APPLICATION NO.	FILING DATE	FIRST NAMED INVENTOR	ATTORNEY DOCKET NO.	CONFIRMATION NO.	
10/660,977	09/11/2003	Tomohiro Fuse	HGM-100-A	5921	
75	90 06/06/2005		EXAMINER		
Carrier Blackman & Associates P.C.			VASUDEVA, AJAY		
Suite 100 24101 Novi Roa	ad		ART UNIT	PAPER NUMBER	
Novi, MI 483			3617		
			DATE MAILED: 06/06/2009	5

DETAILED ACTION

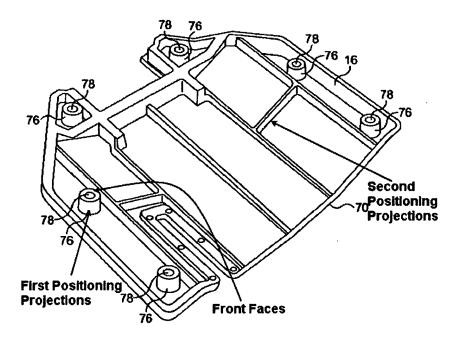
Ménard et al. shows a removable ride plate [16] having a pair of integrally formed left and right <u>first</u> positioning projections [76], and a pair of left and right <u>second</u> positioning projections (see annotated figure below). Both the first and the second positioning projections project upwardly at a front portion of the ride plate (see figures 4, 7 and 8). The positioning projections have <u>horizontally disposed and upward facing</u> front faces for contacting a pair of left and right tab stops formed in a watercraft body (figure 6B).

Re claims 2 and 3, the ride plate comprises an arresting member extending outwardly at the front end (*adjacent numeral 72* in figures 4 and 6B) wherein the arresting member is narrower than the widest part of said ride plate. The arresting member extends vertically higher

Re claims 7 and 8, the second positioning projections have flattened front faces that are substantially vertically oriented, and have a substantially rectangular horizontal cross-sectional shape.
